CITY OF CONWAY, ARKANSAS HISTORIC DISTRICT COMMISSION

HISTORIC DISTRICT COMMISSION

August 25, 2025

A. 931 Faulkner St (HDR-0825-0092) Remodel and New Construction

FAULKNER SIDE-YARD

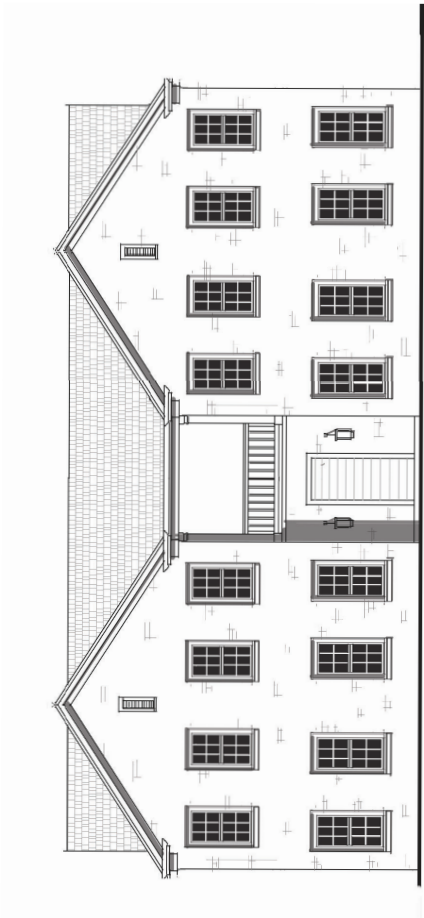
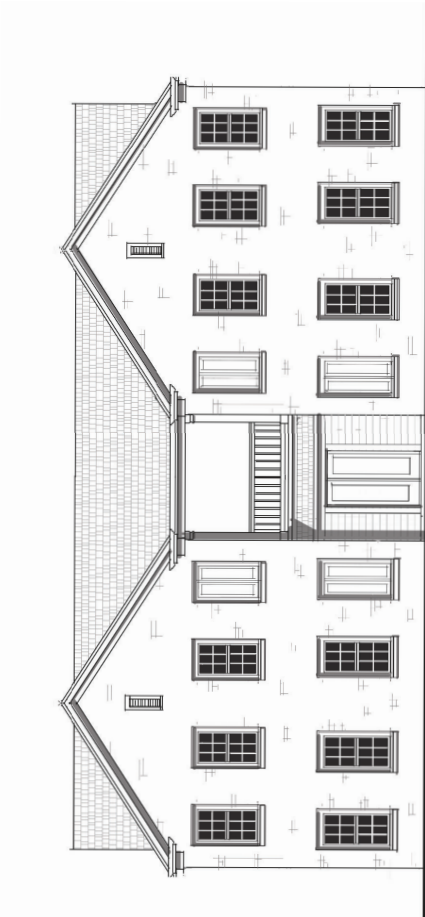
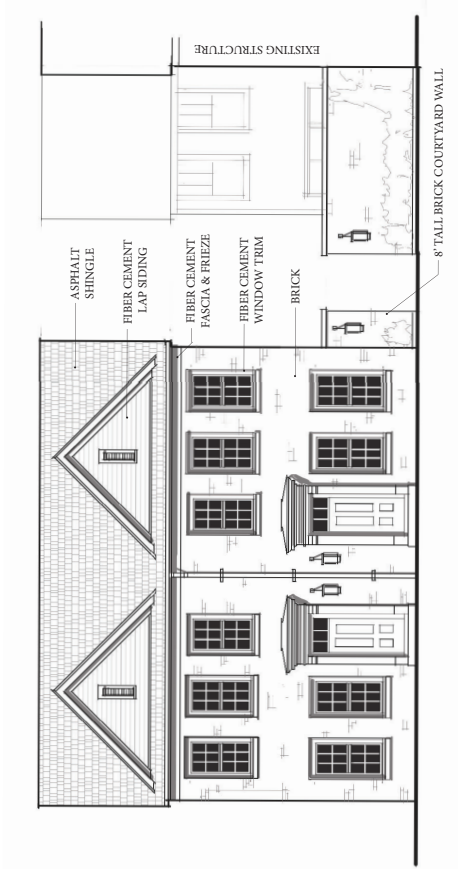
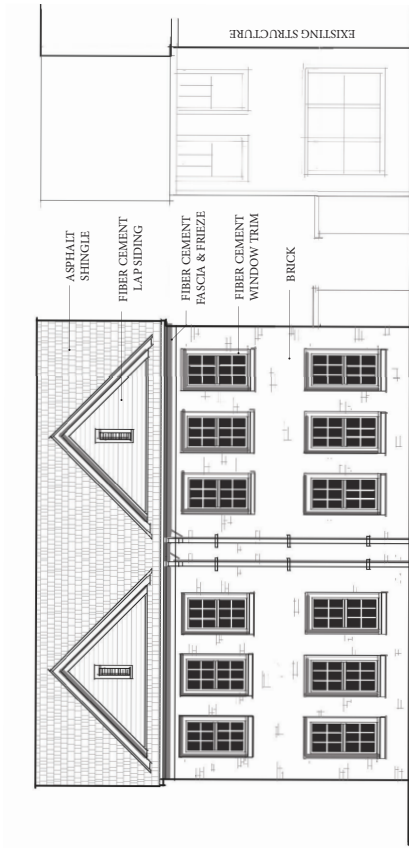
Proposal includes brick, 6" shiplap siding, and board & batten accents. In addition to the brick, the material types will need to be wood or fiber cement. Synthetic siding such as vinyl, aluminum, and synthetic stucco (EIFS products) are prohibited. The proposed material pattern complements that in the neighborhood in terms of variation between different sections of the façades.

Siding and Bricks. The selection of materials for a structure should be compatible with and complement the surrounding structures in the RHD. Brick, stone, and wood are the most appropriate materials for the cladding of structures.
The applicant is proposing brick siding, fiber cement lap siding on dormers, and fiber cement window trim.

Size, Shape, Scale. New construction shall maintain the existing pattern of surrounding historic buildings along the street. Orient the main entrances of the building at the front (street) in a manner similar to established patterns in the district.
The new multi-family building will be set between the existing multi-family structure at 931 Faulkner and another multi-family structure on an adjacent property to the south. The main entrances are oriented towards Faulkner St. Elevations show it as the same height as the existing structure. The existing structure is 30'1" to ridge soffit.

Windows. Select windows and doors for proposed new buildings that are compatible in material, subdivision, proportion, pattern, and detail with the windows and doors of surrounding buildings.
The applicant is proposing six over six windows with fiber cement trim which appears comparable to the trim width of adjacent structures of a similar style. There are dormers with attic vents.

6. Roofing shall be asphalt or composition type shingles. Metal roofing is not allowed.
7. Siding on the new construction shall be composed of brick and wood or a wood-like material such as Hardie ® siding/LP® SmartSide ®.

FAULKNER SIDE-YARD

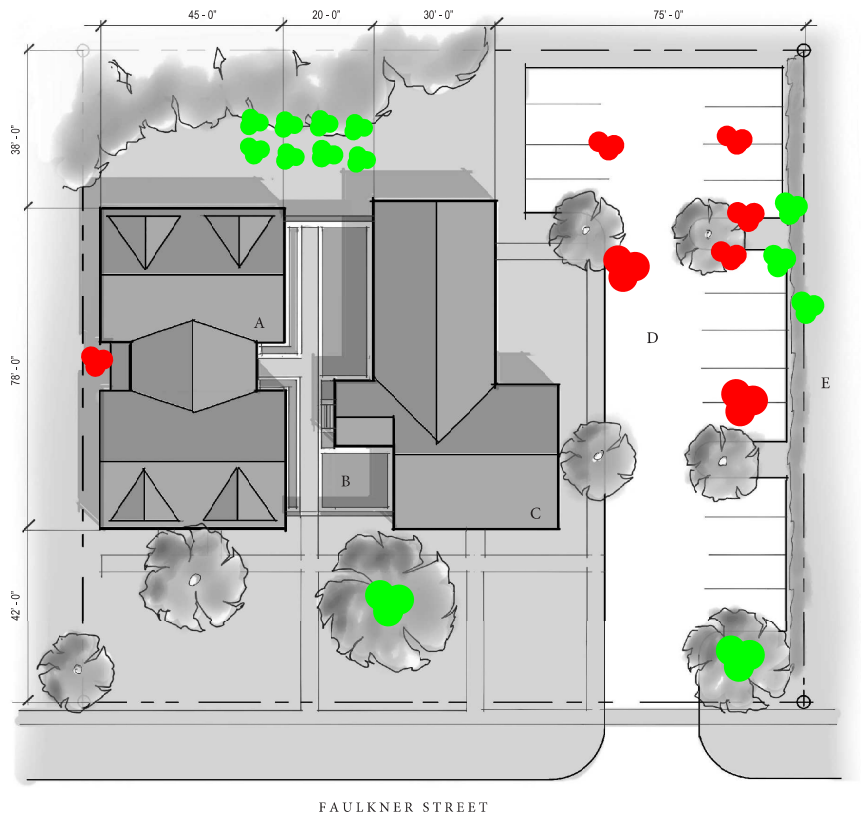
Applicant proposed a curb cut to accommodate a parking lot. The southern curb cut should be closed.

The applicant has indicated that thirteen (13) significant trees will remain and seven (7) will be removed. Five (5) trees along the street frontage are required.

Parking is proposed to the north side of the development. The parking lot will be landscaped.

8. A minimum of five (5) trees from the approved species list or species as otherwise recommended by the Faulkner County Extension Office, must be planted along Faulkner St, outside of the right-of-way.

14. Shrubs shall be planted along the northern property line. They shall be evergreen in nature, be at least 30" tall at the time of planting, have a mature height of at least 3' and be spaced no more than 24" apart on center or the diameter of the specific

1 SITE PLAN
SCALE: 1" = 10'-0"

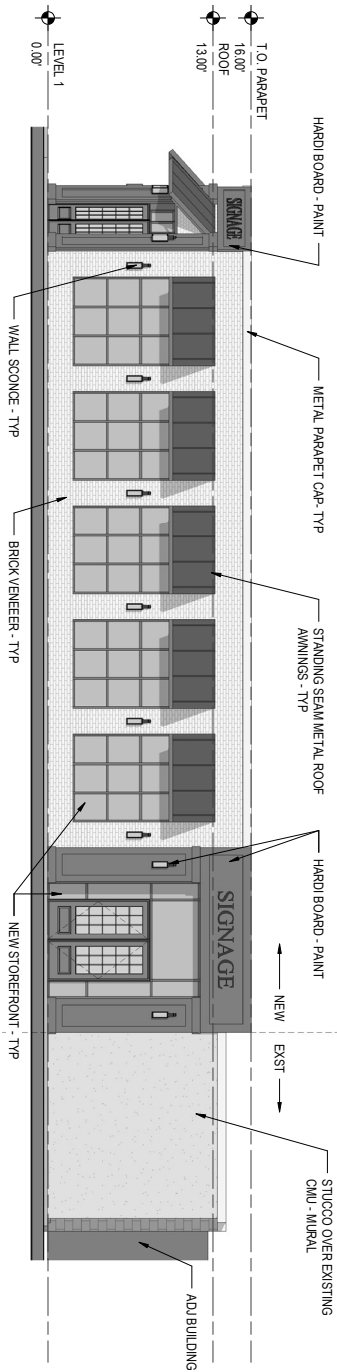
The proposal conforms. The addition will continue with the existing structure's 2'10" setback along the southern property line. There is a 8' proposed setback for the recessed entrance and a 4' setback along the western property line.

A 4' tall decorative steel fence is proposed between the covered patio and the sidewalk along Locust Ave. The steel fence transitions to a brick veneer fence with a decorative steel upper 2'8" along the northern side of the outdoor patio. The percentage of "open" fencing is unclear.

There is an alley to the north of the property but it is not indicated as a public access point. The dumpster and grease pit are adjacent to the alley. If the northern portion is not going to be utilized for parking, ingress/egress should be discouraged through curbing, signage, and/or bollards.

The dumpster enclosure is proposed at the northern portion of the property, adjacent to the alley. A 6' tall masonry dumpster screen and gate to match the building is proposed.

Mechanical equipment is not indicated on the plan but should be screened.

8. Ingress/egress shall be discouraged along northern property line through signage, curbing, and/or bollards.

10. Fencing transparency percentages shall be submitted to Planning Staff for review prior to issuance of a Certificate of Appropriateness.

1 ANGLED WEST ELEVATION
SCALE: 1/8" = 1'-0"

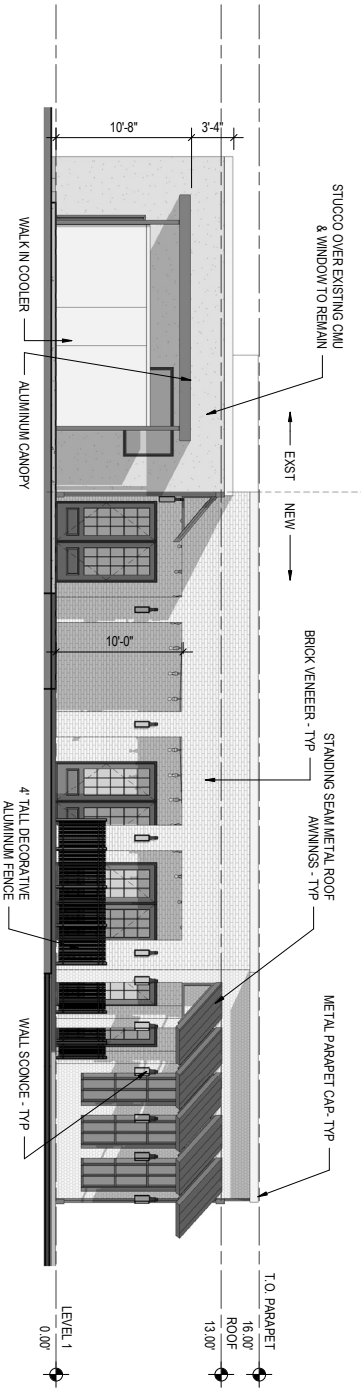
The existing structure is 1 story in height. The addition is also 1 story in height.

The proposed elevations show appropriate articulation with modules and there are no large, unarticulated walls. There is a window or functional public access at least every 10'. The building entries have articulation in the form of awnings, divided light doors and windows, wall sconces, and door settings. The ground floor is a minimum of 2/3 windows. They are not more than three feet above the ground.

5. Metal awnings shall be a minimum of 8' above the sidewalk grade. Their height shall be confirmed during Site Development Review. No cover shall project beyond the curb line of the street.

6. Eighty-five percent (85%) of all first story glazing (windows and doors) shall be transparent and shall be confirmed during Site Development Review.
